Constructing overhead tank in the Jail extension Tumkur town

Subject - CONSTRUCTION OF AN OVER HEAD TANK IN TUMKUR TOWN

Report to accompany the estimate for constructing an R C C overhead tank of 10,000 gallons capacity on 25 ft staging at Jail Extension, Tumkur

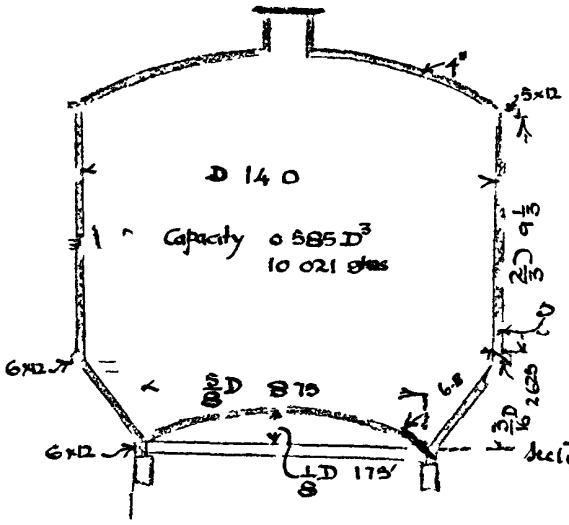
2 The over-head tank is to be of the Intze type being the standard design for tanks of moderately big capacities and also economical compared to the one now proposed The section of the Intze type tank for storing 10,000 gallons, is noted below

Capacity equals 0 585 D^3 equals 10,021 Gls

3 The bracings are to be of 14" X 14" - instead of 12" X 12" as provided now

6 The estimate may be prepared on the above line and sanctioned
